Village of Mukwonago
Notice of Meeting and Agenda

PLAN COMMISSION MEETING
Tuesday, March 10, 2020

Re: Birchrock Retirement Home Planned Unit Development Amendment as Conditional Use and associated Site Plan and Architectural Review and final consideration of architectural elevation
210 McDivitt Lane; MUKV2012215002

To: Peter W. Gesch, P.E.
From: David S. Roberts, P.E.
Re: 210 McDivitt Lane CBRF Addition
JSD Project #: 19-9231
Date: 02/06/2020
cc: Mr. Ben Kohout, Village Planner
John Weidl, Village of Mukwonago
Diana Dkystra, Village of Mukwonago
Bob Harley, Village of Mukwonago
Mark G. Blum, Village of Mukwonago
Dave Brown, Village of Mukwonago
Ron Bittner, Village of Mukwonago
Chief Jeff Stien, Village of Mukwonago
Chief Kevin Schmidt, Village of Mukwonago
Jerad J. Wegner, P.E., Ruekert & Mielke, Inc.
Kris Kiefer, RN, Castle Senior Living

REVISIONS
 SHEET NO. A-400
 DATE: 02-20-20
 JOB NO. 190161-01
 DRAWING BY: JLS 2/20/2020 9:53:37 AM

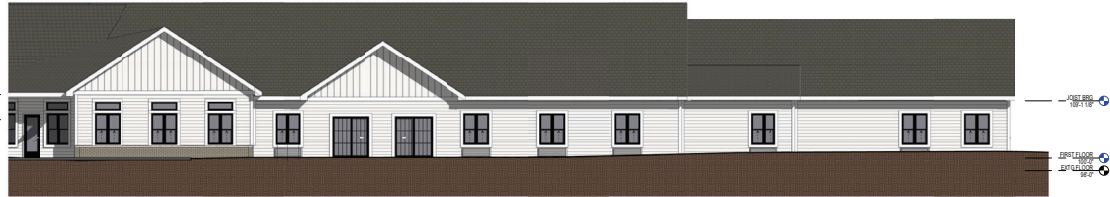
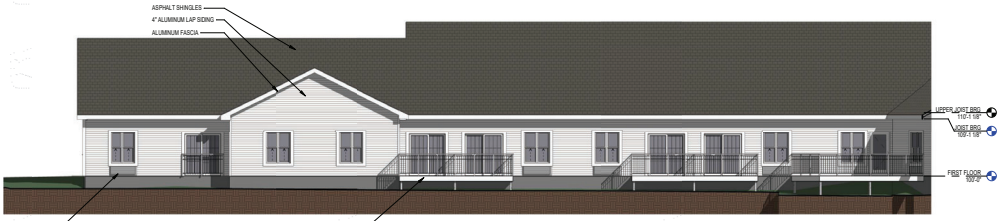
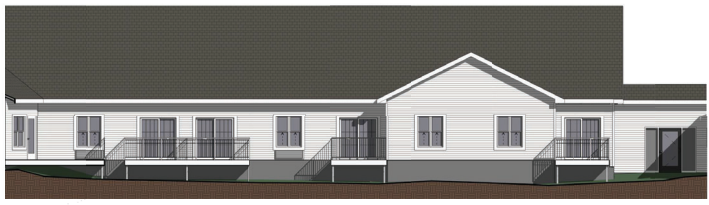
This item remanded back to the March 10, 2020 Plan Commission meeting following being tabled by the Village Board on February 19, so as to see an elevation rendering showing the brick style and placement. The applicant is submitting for review and recommendation a brick placement that is similar to the existing condition and is a tan/beige color and be placed on the gable ends of the structure and on small bands on the lower extremities in other select locations as shown on the plans. The white smart siding look and white aluminum siding will also be proposed to mimic the existing structure so the addition will match.

The Zoning standards for R-10 call for brick or other hardy construction materials. Following discussion at the Plan Commission meeting on February 11, the applicant was directed to match in the addition proposed, the placement, color and materials of the existing structure. This is reflected in the conditions of approval in the proposed resolution.

1. Entry gable ends will be accented with brick or brick veneer matching the existing building.
2. For the R-10 Zoning standards, the rear yard building setback shall be permitted to be amended from the required 40 feet to the shown 24.4 feet, on the provided plan set from the applicant and on file with the Zoning Administrator at Village Hall.
